COMMUNITY DEVELOPMENT DEPARTMENT REPORT

HEARING 7/28/2026
DATE:
TO: Mayor & City Council
FROM: Sonya Allen, Associate Planner
208-884-5533
sallen@meridiancity.org
APPLICANT: SD Land Consulting
SUBJECT: Blueberry Hills Subdivision – AZ, PP
H-2025-0048
LOCATION: 4315 N. Ten Mile Rd., in the NE 1/4 of
Section 34, T.4N., R.1W.

Annexation of 9.36 acres of land with R-4 (7.22 acres) and L-O (2.14 acres) zoning districts; and preliminary plat consisting of 24 buildable lots (20 residential & 4 commercial) and 12 common/other lots of 8.87 acres of land.

F. Preliminary Plat (dated: 5/18/2026)

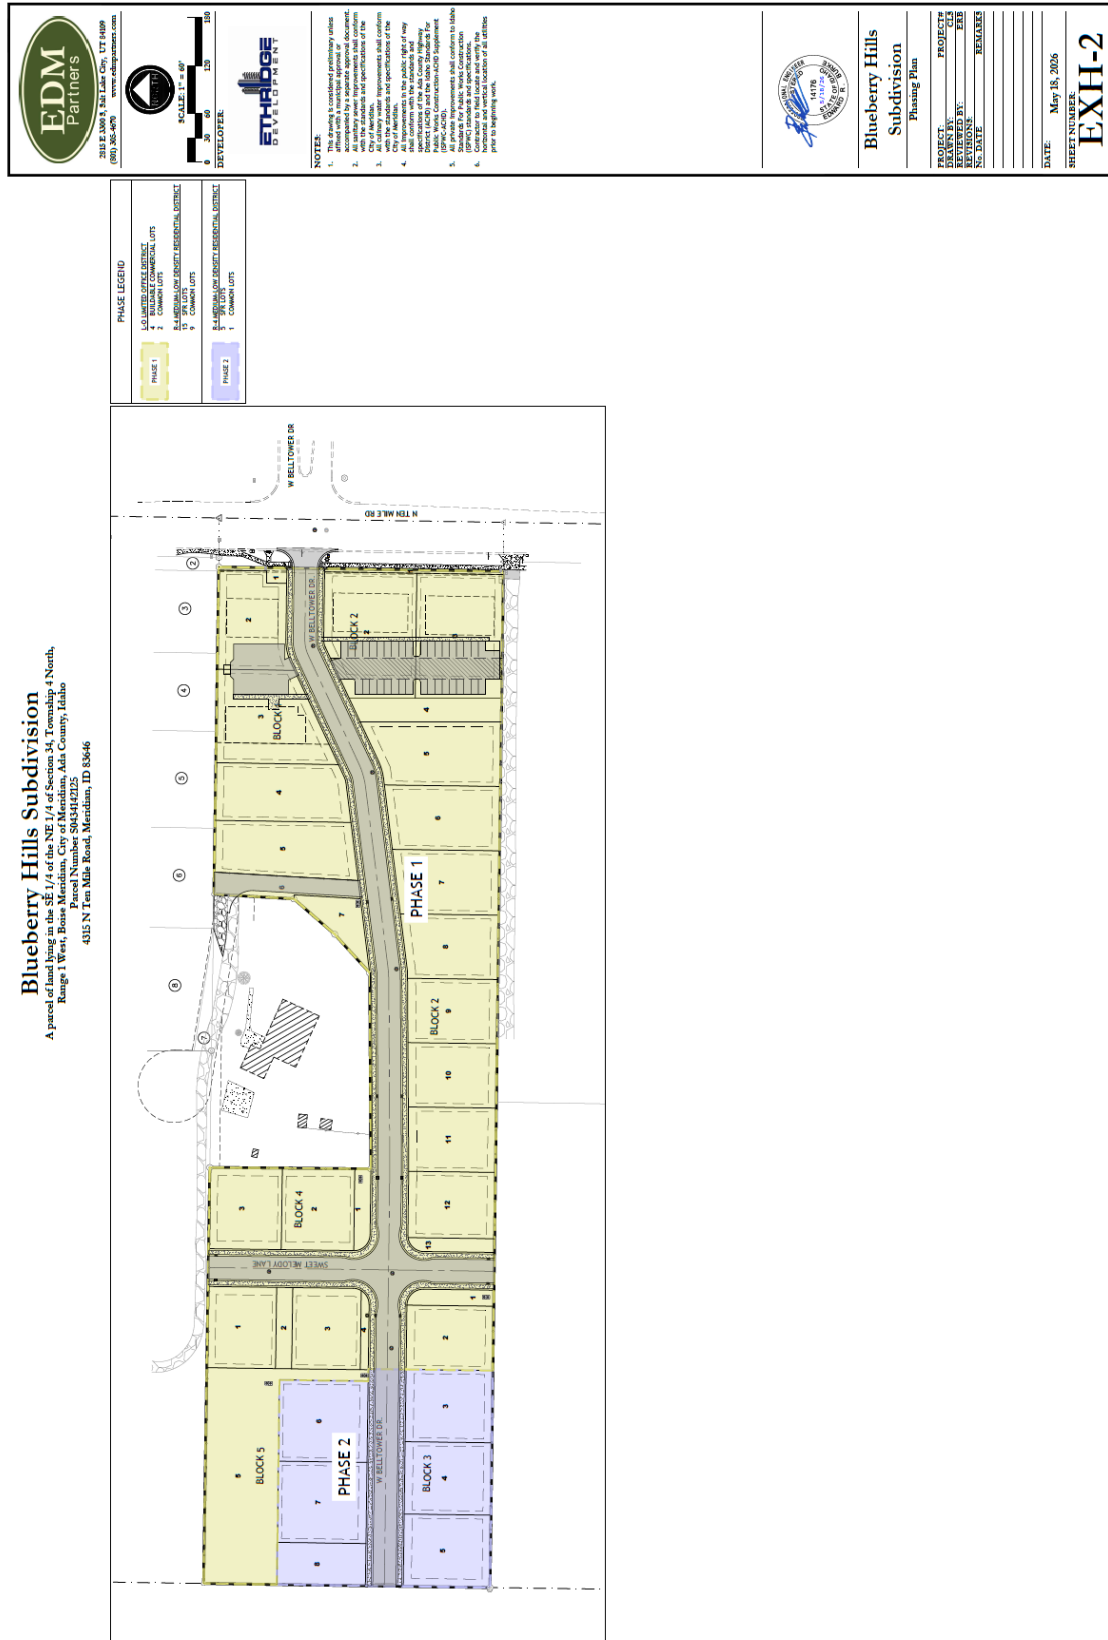
2. The final plat(s) shall include the following revisions:
- i. Include a minimum 15' wide common area along the east side of Lot 6, Block 5 in order to provide the minimum 5' wide landscape strips required along each side of the 5' wide pathway.

- ii. Depict a 10' wide street buffer along W. Belltower Dr. on Lots 2 and 3, Block 1 and Lot 2, Block 2 in a common lot or a permanent dedicated buffer easement.

- iii. Depict cross-access/ingress-egress easements between all commercial lots in the subdivision and to the property to the south (Parcel #S0434142006) either by a recorded easement or as a note on the final plat as set forth in UDC 11-3A-3A.2.

- iv. The post type on the street name "Sweet Melody Lane" shall be changed to align with that for a public street.
 - v. Redesign Belltower Dr. to reduce the length of the street to include the use of passive design elements as required by ACHD (speed humps/bumps and valley gutter will not be accepted as traffic calming).

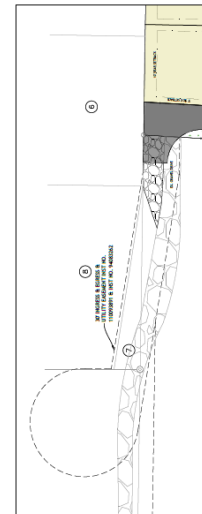
The driveway shall be located on east side of lot per UDC 11-6C-3D.5
